CONTRACT DOCUMENTS, SPECIFICATIONS
AND
CONTRACT DRAWINGS
FOR
ASCENSION PARISH

Channel Improvements at
Sides Bayou, Courthouse Lateral, & Bayou Francois Lateral
Task Order #2021-HEI-001, #06-EAD-2021, & 07-EAD-2021

ADDENDUM NO. 1

DATE ISSUED: February 23, 2023

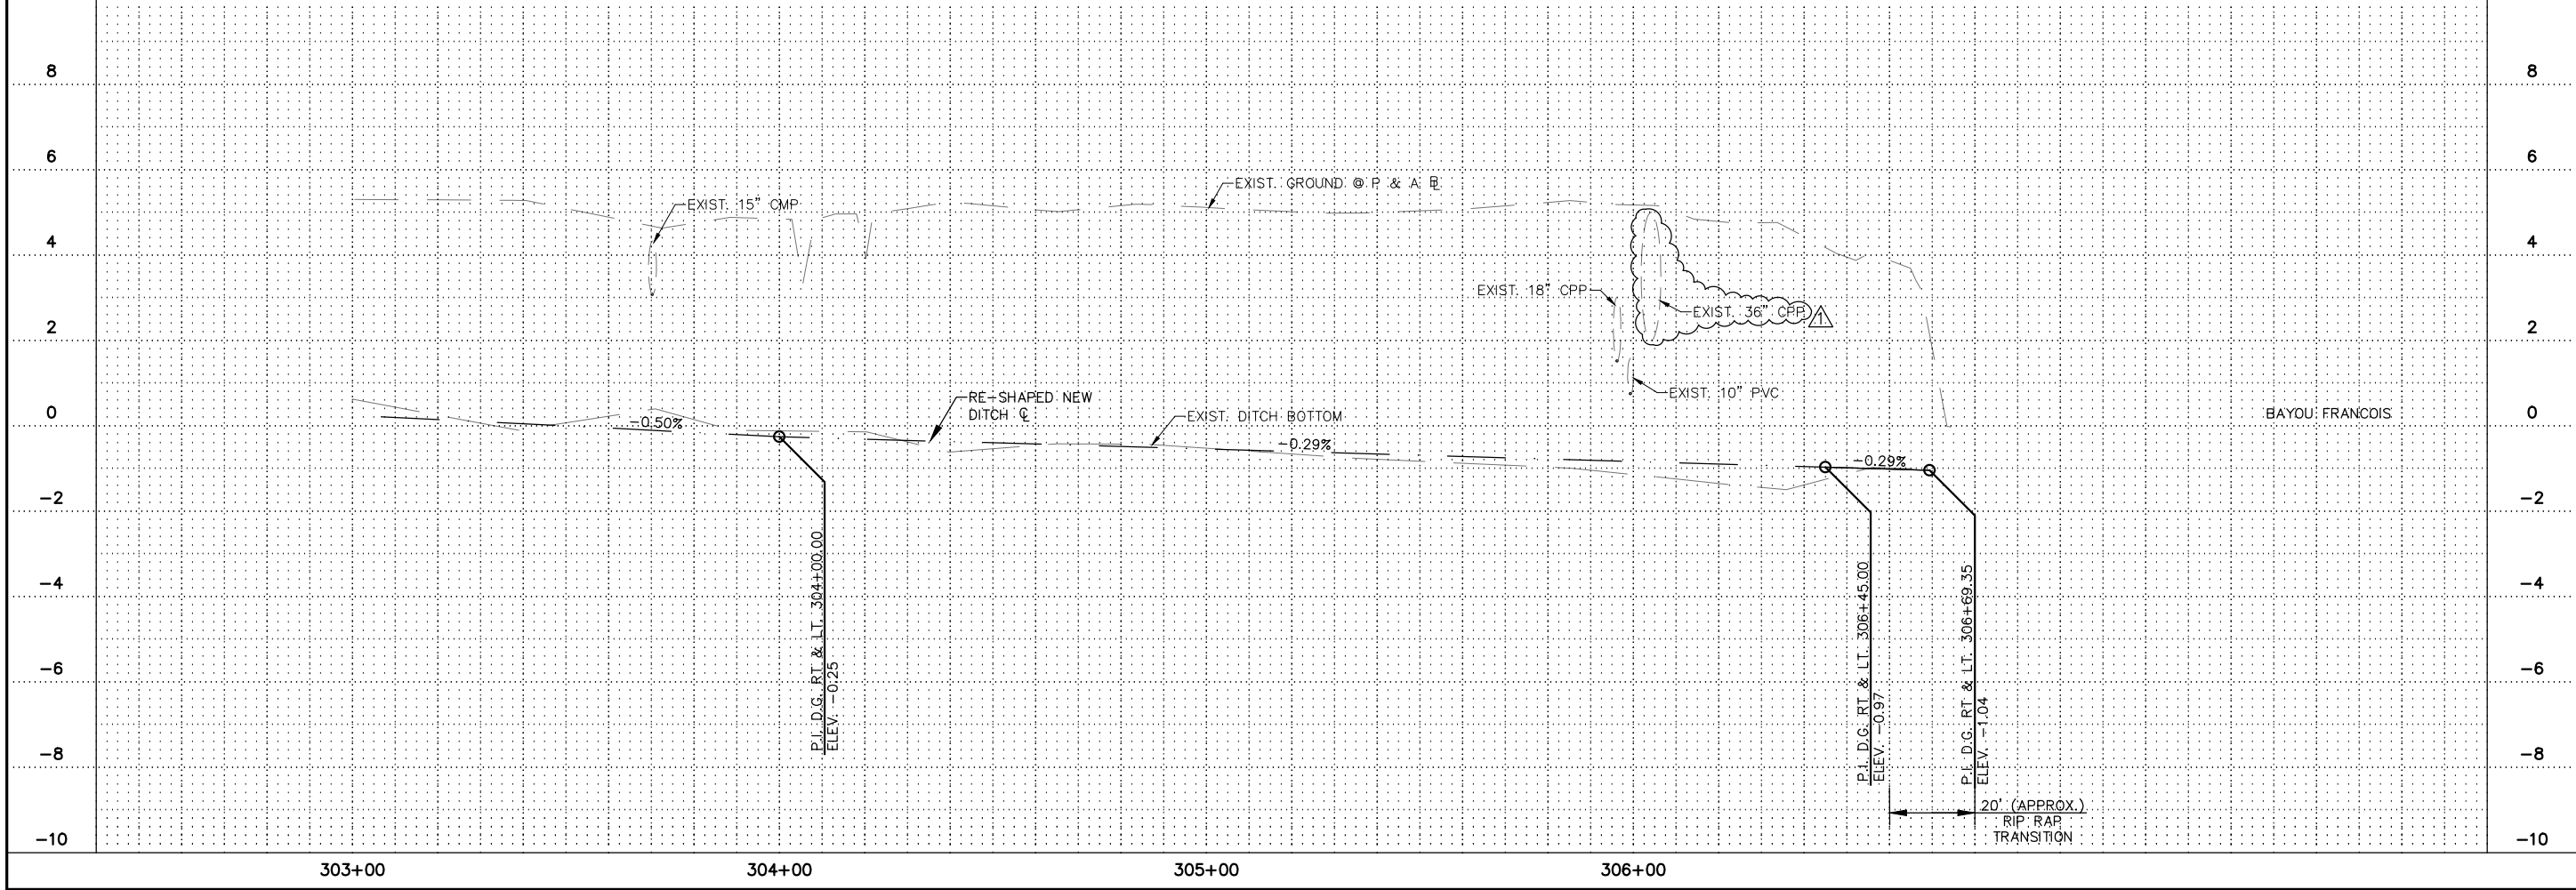
- A3.** Nonwoven under Fabric-Formed Concrete
- Q4.** Aggregate Surface Course 401.01 – to be installed per typical cross sections shown on plans. Is this pertaining to the pipe and catch basin installation? Also, will aggregate be required under the 6” driveway replacement: If so, how thick?

Q3. Sheet 4 – there is a light pole for the service to the resident that appears to be located in the turn down area of the Fabric formed concrete. Please advise.

- A4.** See Revised Sheet 3a for Pipe and Catch Basin Bedding Details. Driveway will have 6” Stone Bedding.
- Q5.** Concrete Walks, Drives, and Incidentals 706 – what kind of re-inforcement will be required?

A3. Form the Fabric around the Power Pole similar to detail on Sheet 3a.

PENETRATIONS THROUGH THE MATTRESS SHALL BE FIELD CUT AND SEWN AROUND THE OBJECT TO FORM A TIGHT SEAL. A CORD OR PIECE OF ROPE CAN BE SEWN INTO THE FABRIC TO ENSURE A TIGHT SEAL BY TYING OFF AROUND THE OBJECT. ANY OPEN SPACES OR VOIDS THAT MAY OCCUR SHOULD BE FILLED WITH GROUT TO ENSURE A TIGHT SEAL.
